**MAINE TURNPIKE AUTHORITY**

**ADDENDUM NO. 1**

**CONTRACT 2022.08**

**LITCHFIELD 8-BAY GARAGE REPLACEMENT**

WATER TREATMENT PIPING PLAN

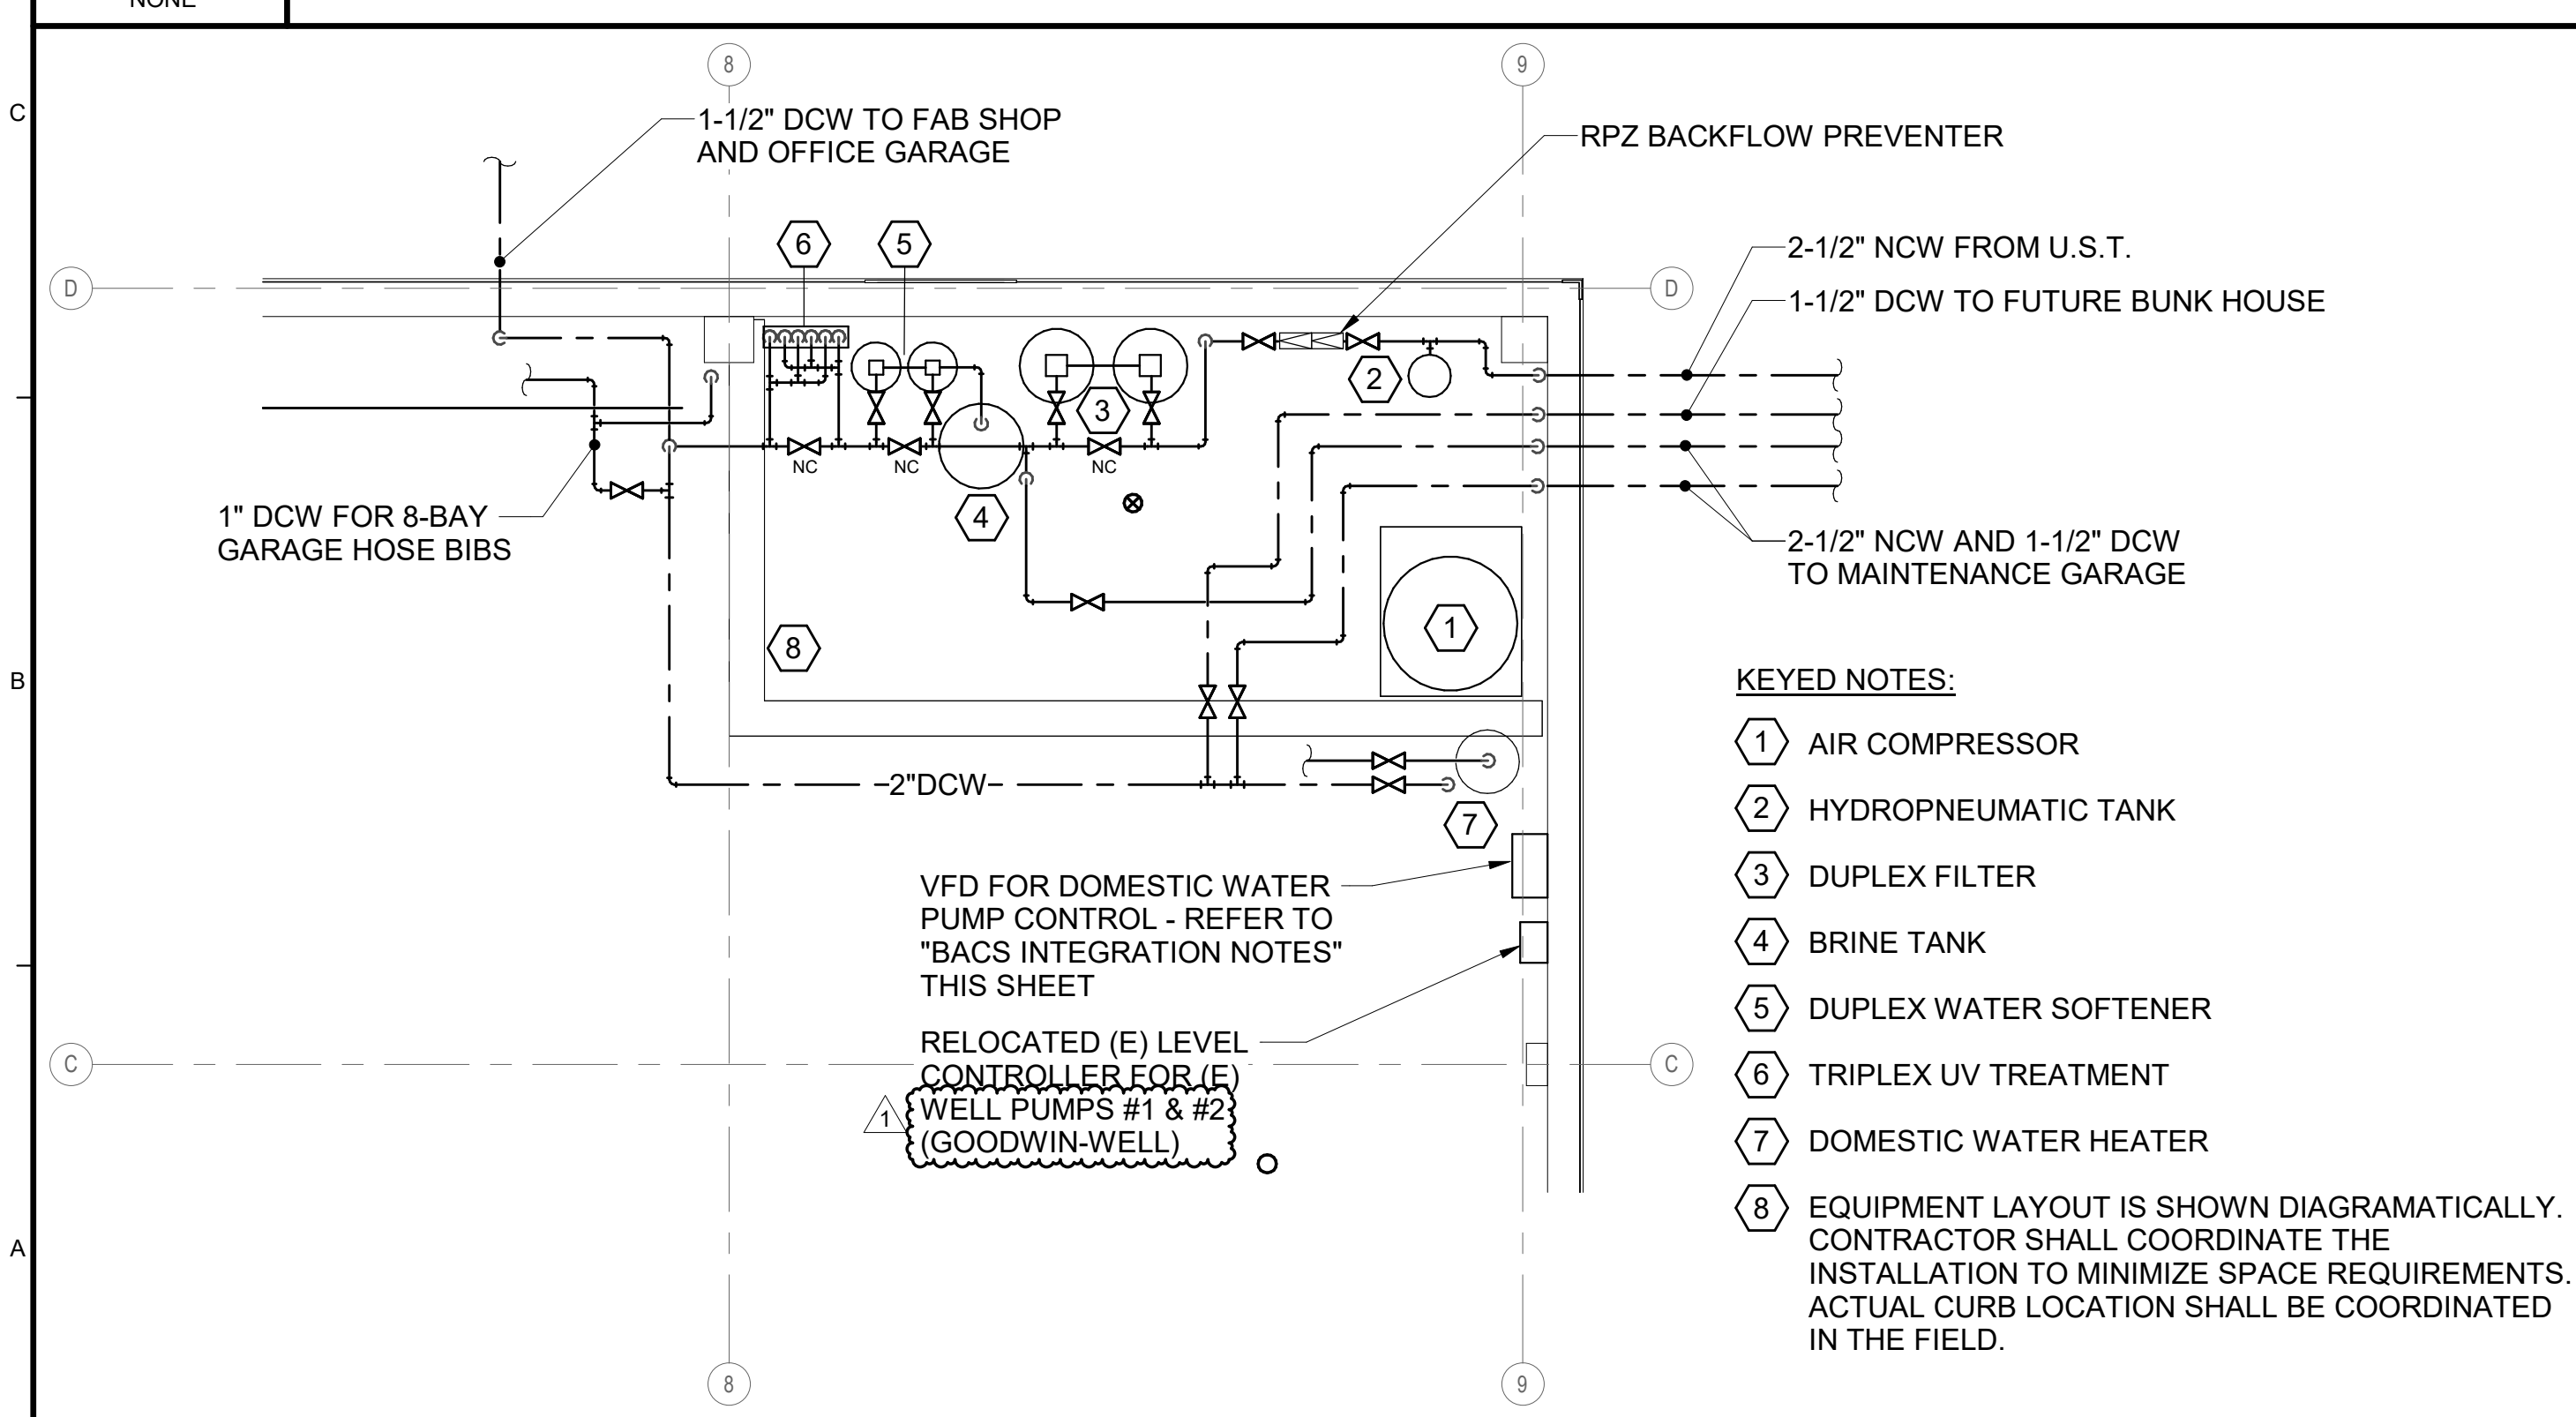
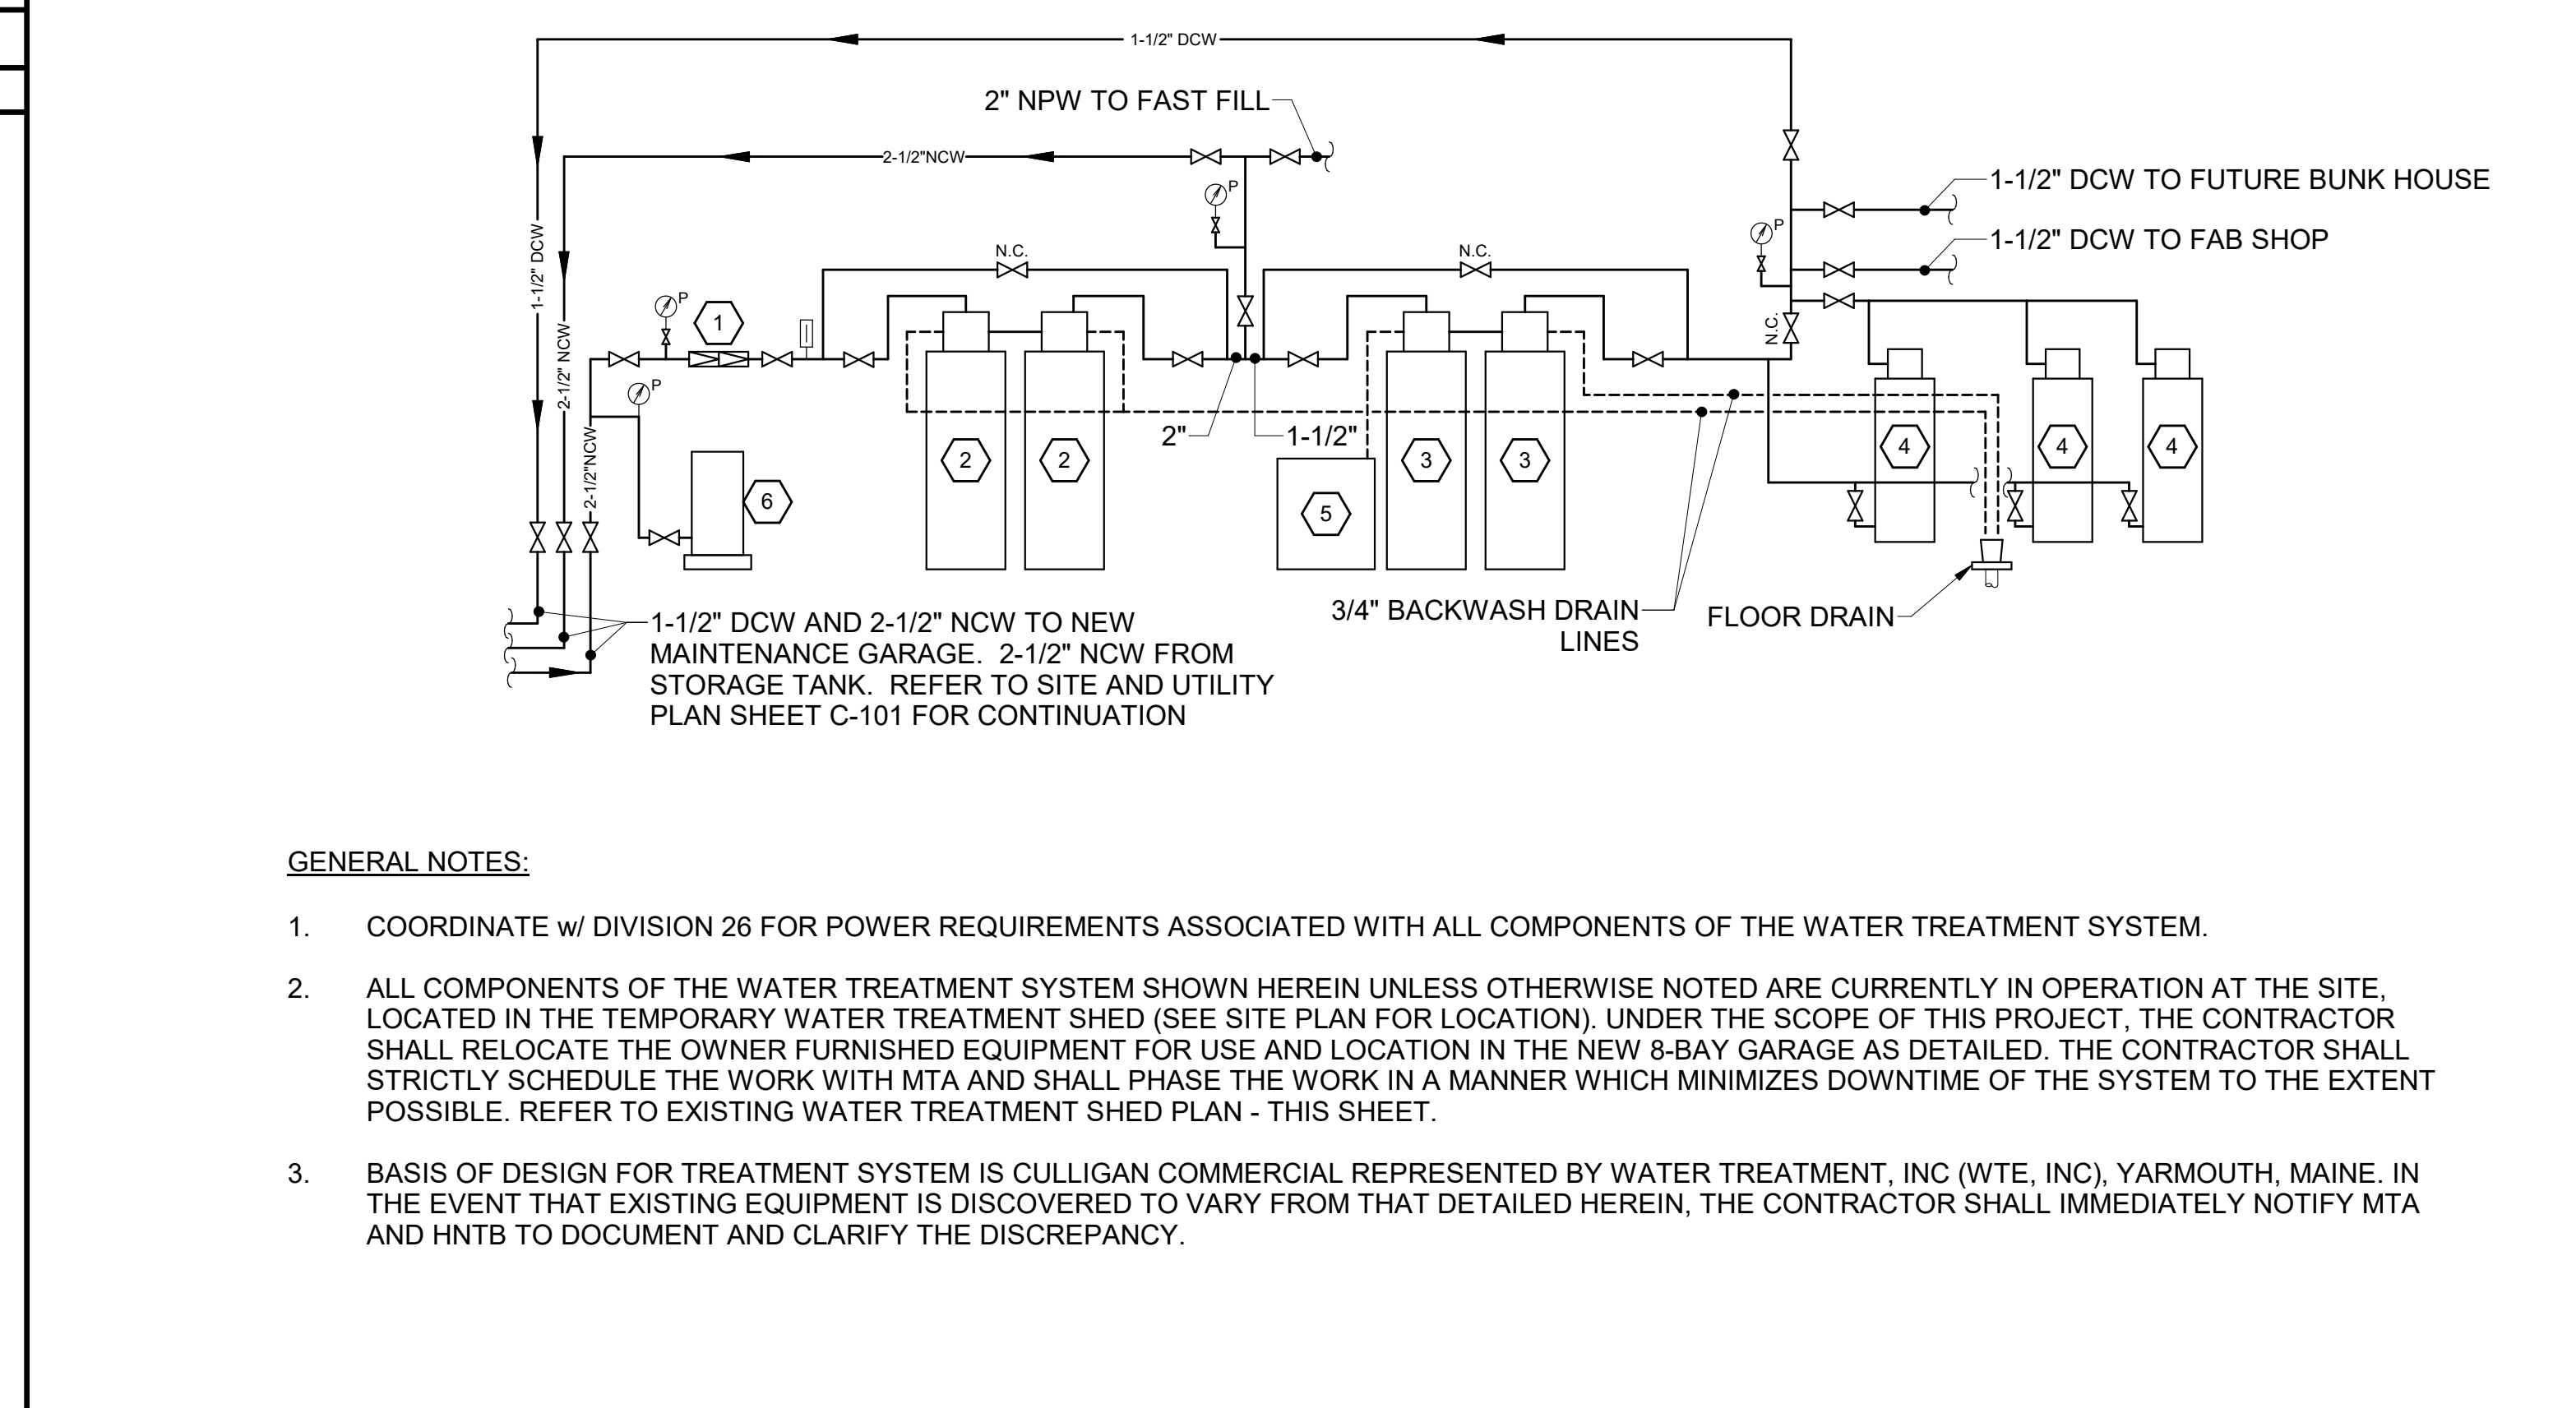
15. A highway class paver with an eight to ten foot screed (CAT AP555E or similar) will be allowed.
- Plan Sheet 27 - Water Treatment Piping Plan: **DELETE** the sheet and **REPLACE** it with, Plan Sheet 27, attached hereto with revisions.
